L71X-
A.01.14

A/C pressure sensor update

All Lamborghini Models Gallardo LP Coupé and Spyder all versions from MY 2009 to MY 2014.

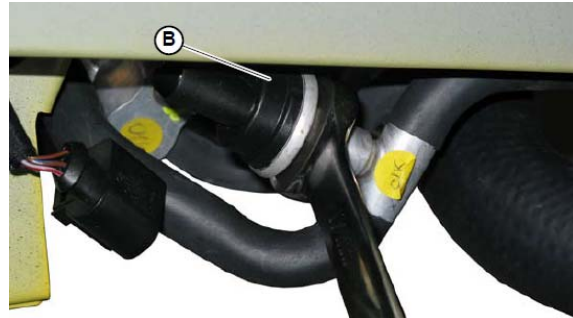
3. Unplug pressure sensor connector.

4. Unscrew and remove pressure sensor.

Pressure sensor tightening
Torque: **5Nm (3,69 lbf ft)**

Replace Sensor seal ring (p/n 7H0820896)
at each sensor replacement.
